**INTERNATIONAL CODE COUNCIL
2012 CODE DEVELOPMENT CYCLE**

**2012 REPORT OF THE PUBLIC HEARING
ON THE 2012 EDITIONS OF THE**

INTERNATIONAL BUILDING CODE®

**HELD IN DALLAS, TEXAS
APRIL 29TH – MAY 6TH**

IBC 1004.1, Example D

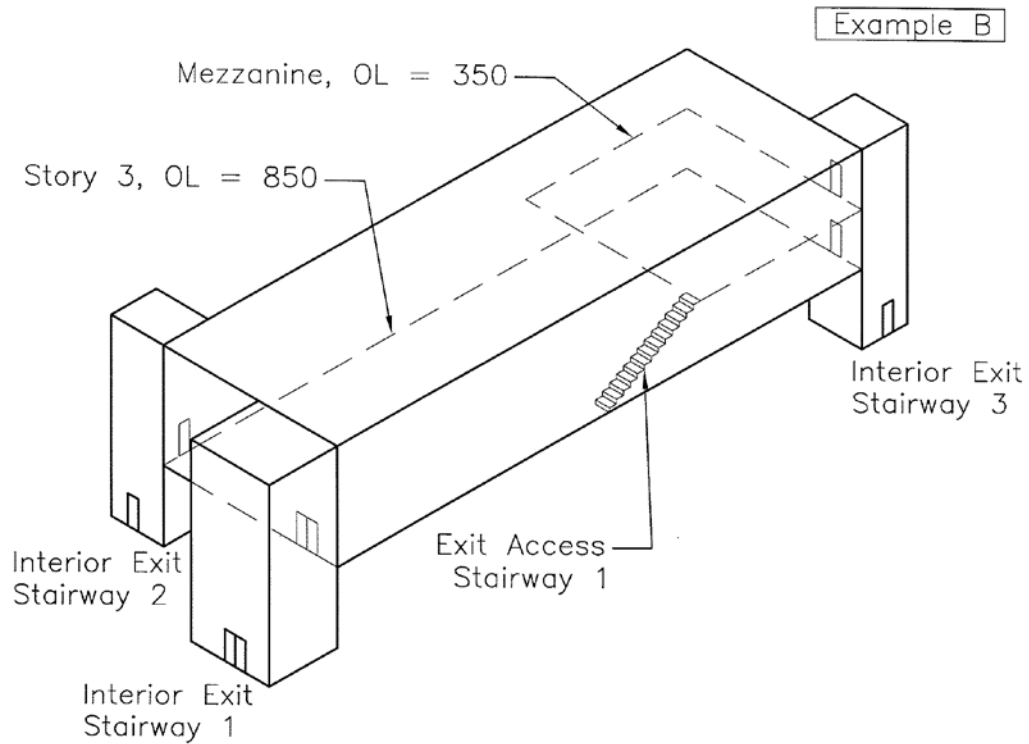
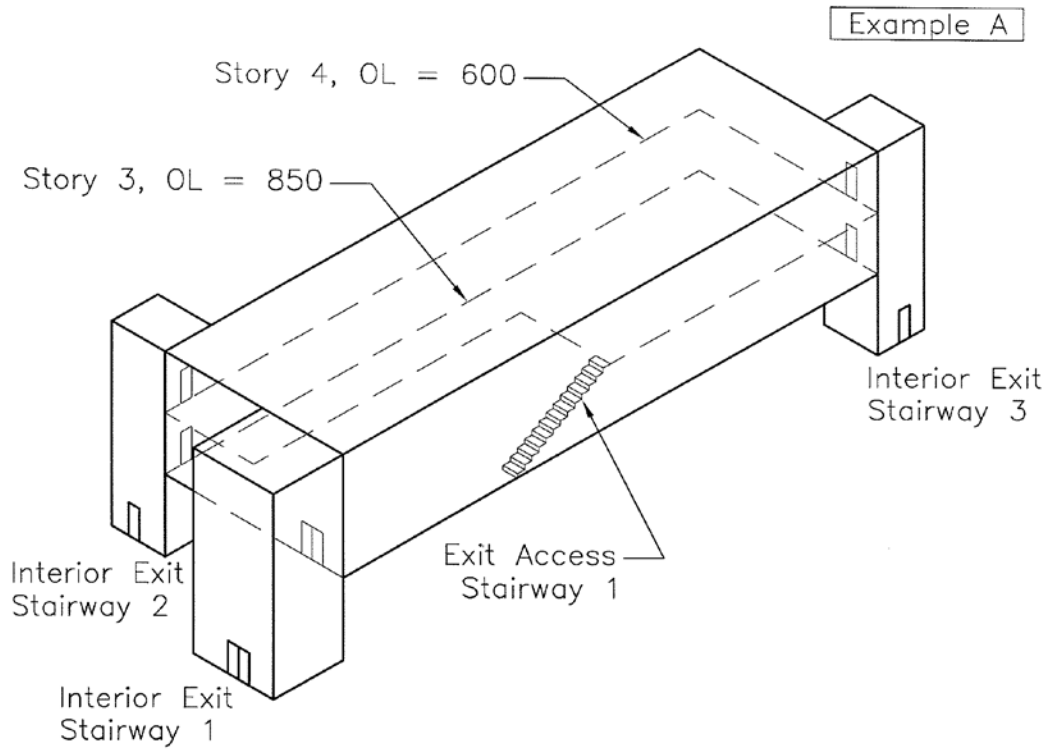
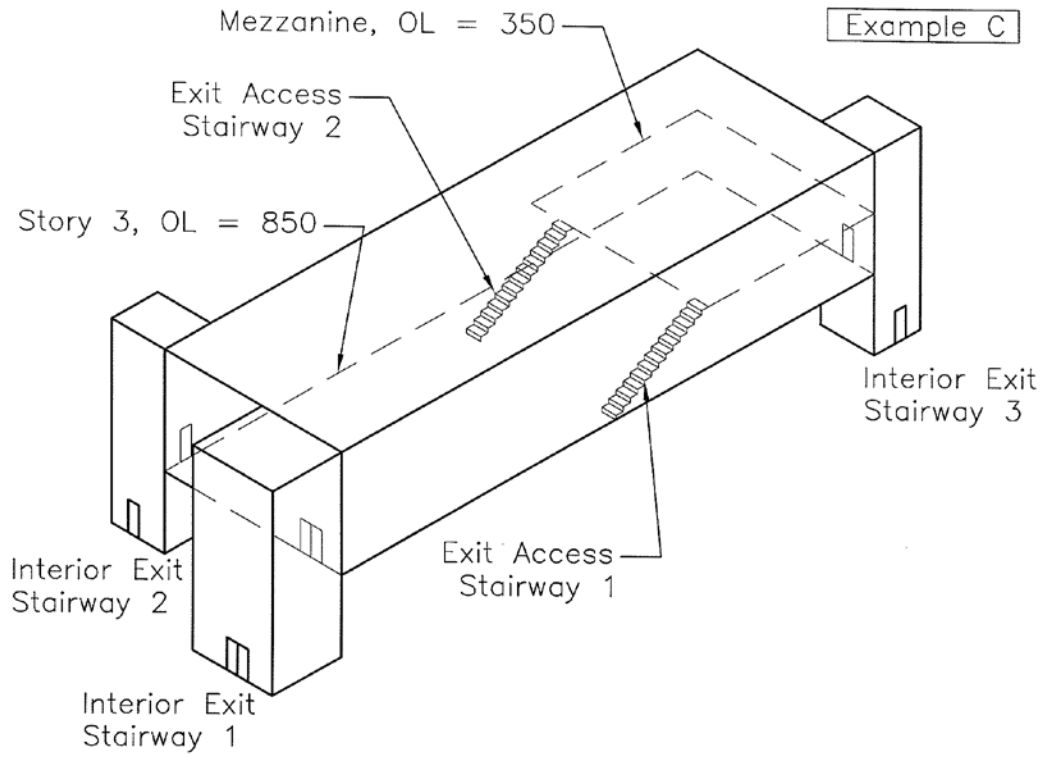
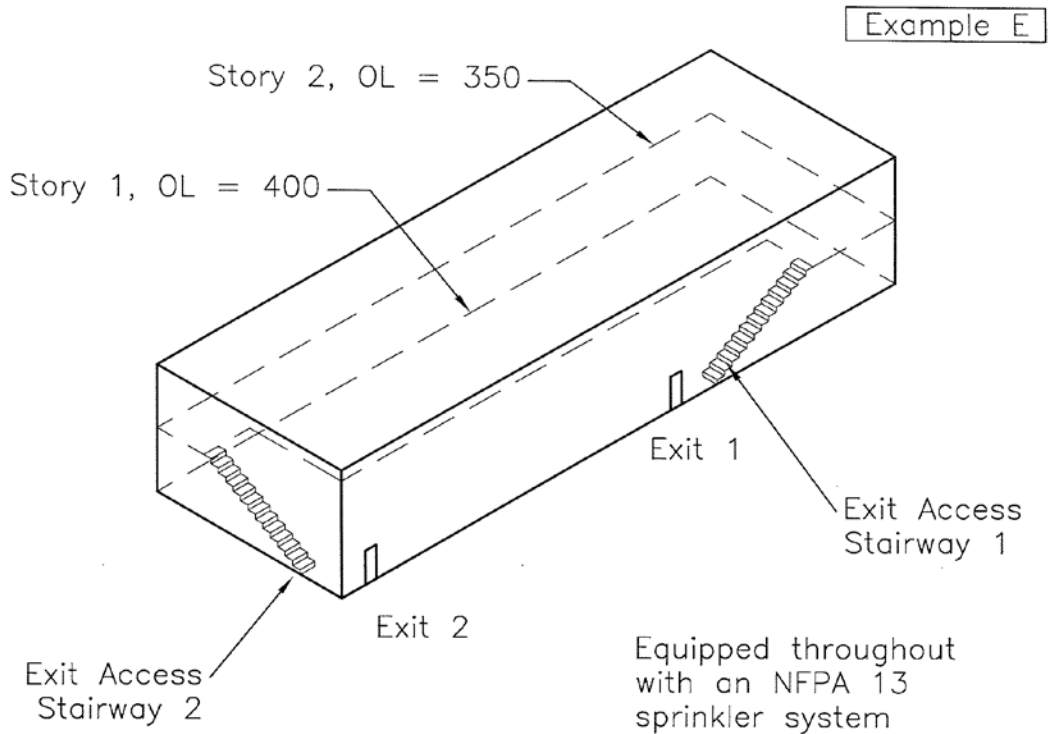
In layout D.2, all rooms have adequate means of egress for the occupant load contained in the room when evaluated on an individual basis. The occupant load of the entire story is still 700 and the story has an adequate number of exits when looked at in the aggregate (doors 3.2, 5.2 and 7.2). Since the sales office also has required egress through the general office, the accounting office, general office and sales office must be looked at in the aggregate and based on the total aggregate occupant load of 680 for this portion of the exit access. Three exit or exit access doors are required and provided from this portion of the exit access (door 3.2, 5.2, and 6.2). The capacity of door 5.2 and 6.2 must be designed based on an accumulated occupant load 270 along each egress path which is determined as follows: (140, the portion from the sales office, plus 100 from the accounting office, and 300 from the general office) all divided by 2= 270. The capacity of door 7.2 is determined based on the occupant load of 270 used to determine the occupant load of door 6.2 along with the accumulated occupant load of 20 from the lobby for a total occupant load of 290 for the capacity of door 7.2 along the continuation of this egress path. This is consistent with Figure 1004.4.4 of the 1012 IBC Commentary and its accompanying explanation.

Egress in layout D.2 would meet the code as revised by the proposed change.

This example has adequate egress from each room, story and portion of the exit access when considered in the aggregate but it would not comply with the 2009 IBC because all occupants do not have access to all required exits from the story as was required by 2009 IBC section 1021.1 This was resolved by E5 and E120 in the past code cycle. This example would also not comply with the literal read of the 2012 IBC because all of the occupant load from the sales office and the accounting office would be added to the general office for a total of 680 requiring three means of egress from the general office.

Example E: This example illustrates an egress system allowed for occupancies other than H and I in the first two floors of a building equipped throughout with an NFPA 13 sprinkler system. This arrangement was allowed under the 2006 IBC section 1020.1, exception 9 without adding the occupant load to the floor below. This code change would continue to allow this configuration as long as the capacity from each floor is maintained as required by the code.

This configuration would apparently not meet the current code as the occupant load or a portion of the occupant load from the second floor would currently be required to be added to the occupant load of the first floor causing the occupant load to have three exits. This was apparently an unintended consequence of E122 06/07.

This code change would still require occupant load from an adjacent story or level to be added to an adjacent level when the sole egress occurs through the story. This code change provides a framework utilizing existing exceptions for the egress through an adjacent story or level to be considered in a similar manner depending on the degree of independent egress from the story or mezzanine.

Committee Reason: The proposal seems to treat the 2nd floor like a mezzanine regardless of how close the exit access stairways are to the exterior exits in the level of exit discharge. This would be in conflict with the cascading stairway loading that has been utilized in the code for years. "Loss of exit access" is too open for interpretation. The proposed language is very confusing. The intent is not clearly expressed. Disapproval is also consistent with the committee vote on E17.

**FIGURE 2308.9.3.2
ALTERNATE BRACED WALL PANEL ADJACENT TO A DOOR OR WINDOW OPENING**

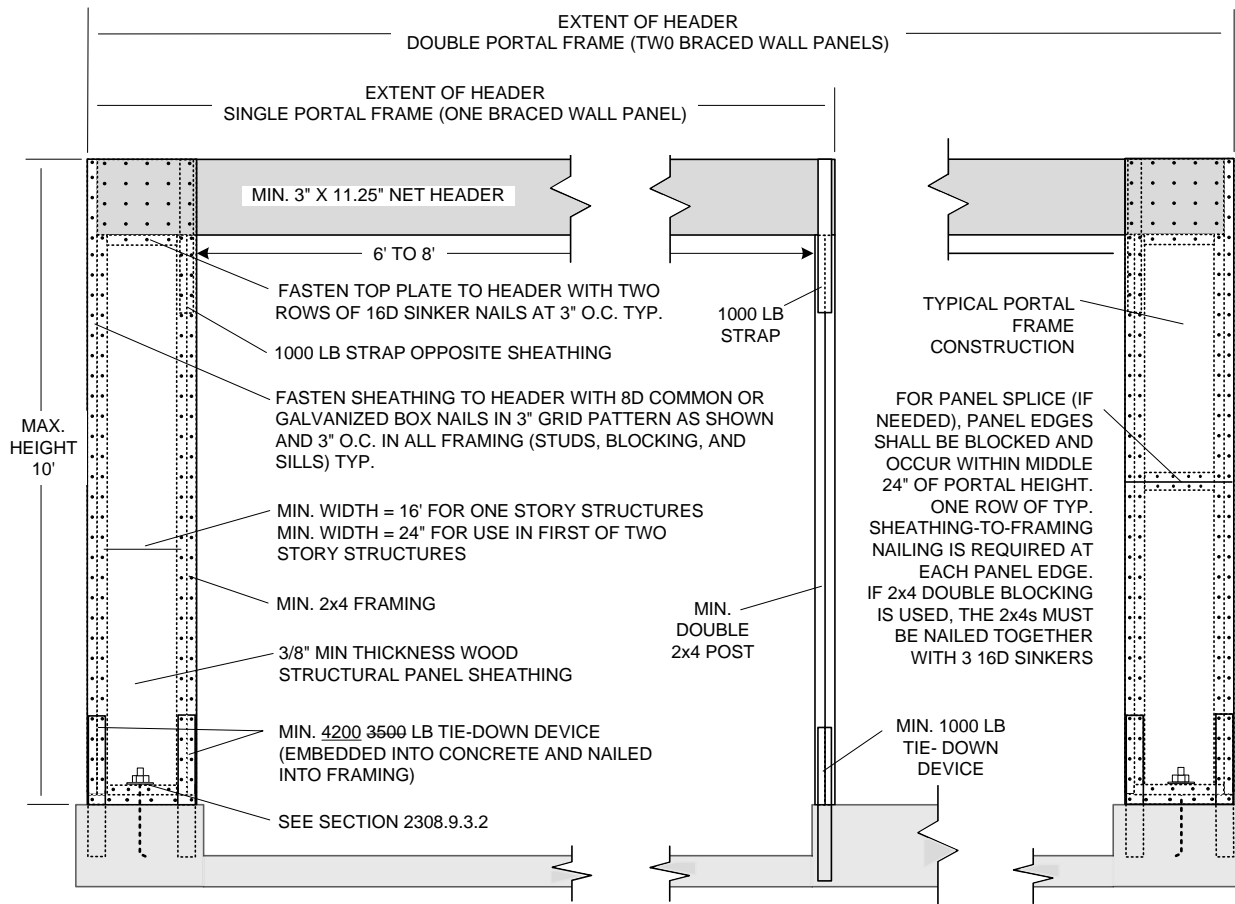
1. In one-story buildings, each panel shall have a length of not less than 16 inches (406 mm) and a height of not more than 10 feet (3048 mm). Each panel shall be sheathed on one face with a single layer of 3/8 inch (9.5 mm) minimum thickness wood structural panel sheathing nailed with 8d common or galvanized box nails in accordance with Figure 2308.9.3.2. The wood structural panel sheathing shall extend up over the solid sawn or glued-laminated header and shall be nailed in accordance with Figure 2308.9.3.2. A built-up header consisting of at least two 2 x 12s and fastened in accordance with Item 24 of Table 2304.9.1 shall be permitted to be used. A spacer, if used, shall be placed on the side of the built-up beam opposite the wood structural panel sheathing. The header shall extend between the inside faces of the first full-length outer studs of each panel. The clear span of the header between the inner studs of each panel shall be not less than 6 feet (1829 mm) and not more than 18 feet (5486 mm) in length. A strap with an uplift capacity of not less than 1,000 pounds (4,400 N) shall fasten the header to the inner studs opposite the sheathing. One anchor bolt not less than 5/8 inch (15.9 mm) diameter and installed in accordance with Section 2308.6 shall be provided in the center of each sill plate. The studs at each end of the panel shall have a tie-down device fastened to the foundation with an uplift capacity of not less than ~~4,200~~ ~~3,500~~ pounds (18 480 15-570 N).

- In the first story of two-story buildings, each wall panel shall be braced in accordance with Item 1 above, except that each panel shall have a length of not less than 24 inches (610 mm).

Committee Reason: This proposal updates the prescriptive portal frame bracing alternative. The modification is acknowledges that the hold-down capacity needs to remain 4200 pounds.
